**ITEM 5. DEVELOPMENT APPLICATION: 115-119 BATHURST STREET SYDNEY****FILE NO: D/2013/1822****DEVELOPMENT APPLICATION NO: D/2013/1822****SUMMARY**

**Proposal Summary:** Stage 2 integrated development application for partial demolition of the existing buildings and construction of a 67 storey mixed use building accommodating 490 residential apartments, 2,004sqm of 'creative hub floorspace', 373sqm of retail floor space and 267 car parking spaces including the adaptive re-use of the existing heritage building (at 339 Pitt Street) as a 173 room hotel with associated landscaping and public domain improvement works.

**Figure 23: Cross-section of proposed upper level balconies**

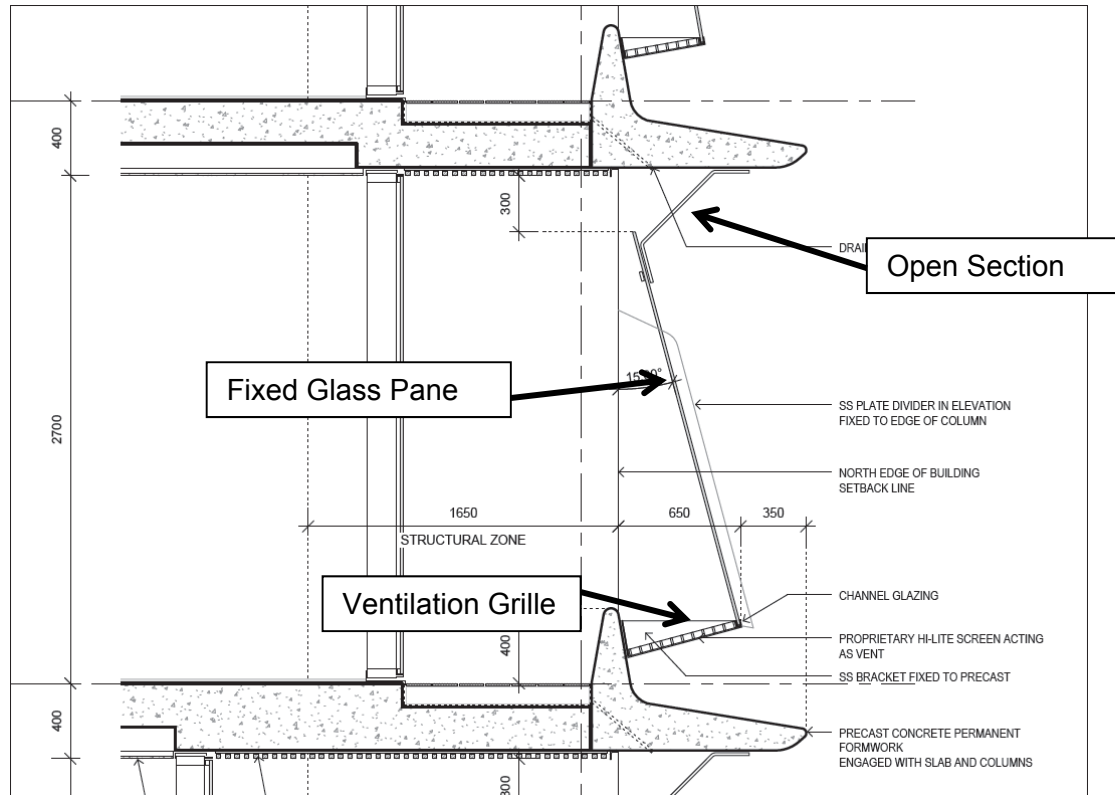
58. Between levels 25 and 66, the applicant proposes to provide balconies that are partially enclosed with ventilation grilles at the bottom edge and an open top section above a 2.2 metre high glass enclosure. A photomontage and a cross-section showing the proposed balconies is provided below:

- (C) the Central Sydney Planning Committee endorses the preparation of a planning proposal and accompanying Development Control Plan amendment to allow the floor area of a balcony to be excluded from the calculation of gross floor area in cases where the outer walls of the balcony exceeds 1.4 metres in height to provide wind protection in circumstances to be outlined in the proposal;

Figure 24: Extract from plan showing '1 bed' unit

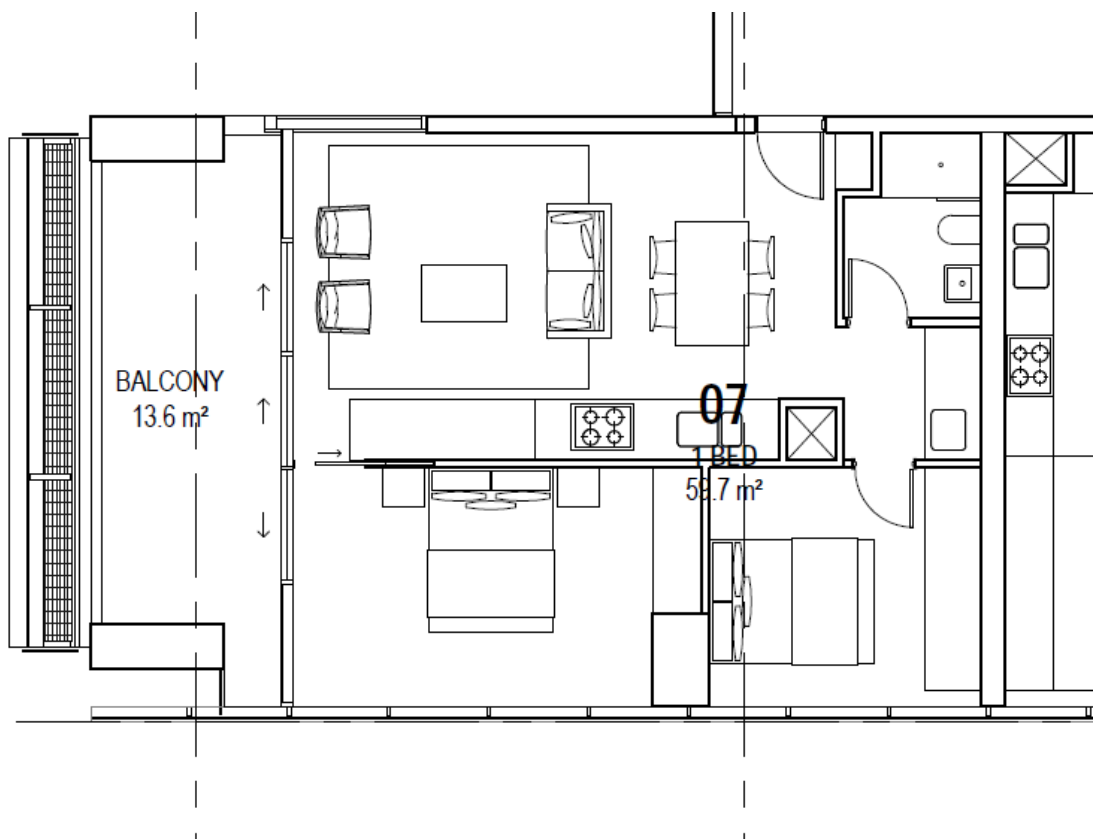
75. Of the apartments proposed (74 x studio, 160 x 1 bed, 171 x 2 bed, 85 x 3+ bed), the 1 bed, 2 bed and 3 + bed apartments all comply with the standard minimums for the apartment types proposed. Of the studio apartments proposed, approximately two thirds are between 0.9 – 1.1sqm below the prescribed minimum of 38.5sqm. However, at 37.4sqm, the smallest of these will be just over 1sqm short of the specified minimum. As this is minor, this is considered acceptable.
76. On inspection of the submitted plans, it is noted that 15 of the units noted as being 1 bed (and included in the number of 1 bed units proposed) contain 2 bedrooms. A typical plan of these is shown below:

77. In all of these cases, the sizes of the units are smaller than the prescribed minimums for 2 bed units. A condition is recommended requiring these to be amended to one bed with study apartments.

- (a) The westernmost south facing apartments on levels 25-35 inclusive and numbered [unit number=*n*] n.08 shall be restricted to 1 bed in size as shown on DA drawings. The second bedroom shown on the submitted plans shall be reconfigured as a study with study furniture. All sales documentation shall ensure that these are accurately described as a 1 bed with study apartment.

- (b) The westernmost south facing apartments on levels 36-40 and 43-45 inclusive and numbered [unit number=*n*] n.07 shall be restricted to 1 bed in size. The second bedroom shown on the submitted plans shall be reconfigured as a study with study furniture. All sales documentation shall ensure that these are marketed as a 1 bed with study apartment.

**Figure 25: Typical creative hub Level 3 of redeveloped 1965 building showing overhang shaded**

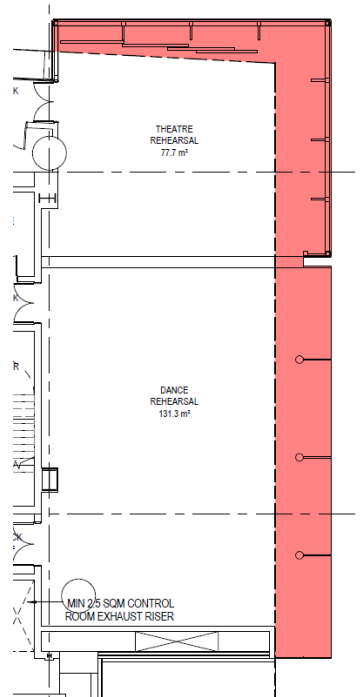
83. As already noted above, the proposal has been the subject of a design competition. In addition, the subject application has been referred to the Design Advisory Panel for consideration and has been assessed by Council's Urban Design and Heritage specialists.
84. The Design Advisory Panel generally commended the scheme but recommended some design modifications. As a result, a number of design modification conditions have been included.
85. As also noted above, the proposal includes an 'overhang' of Council's footpath at the corner of Pitt and Bathurst Streets on levels 2-4 of the building. The extent of this overhang will encroach over the footpath by approximately 2m and is shown shaded on the plan below:

86. On considering the overhang in particular, the Design Advisory Panel asked for views north and south along Pitt Street to be provided to assess the visual impacts of the projection and for the design of the overhang to be further developed. These photomontages are shown below:
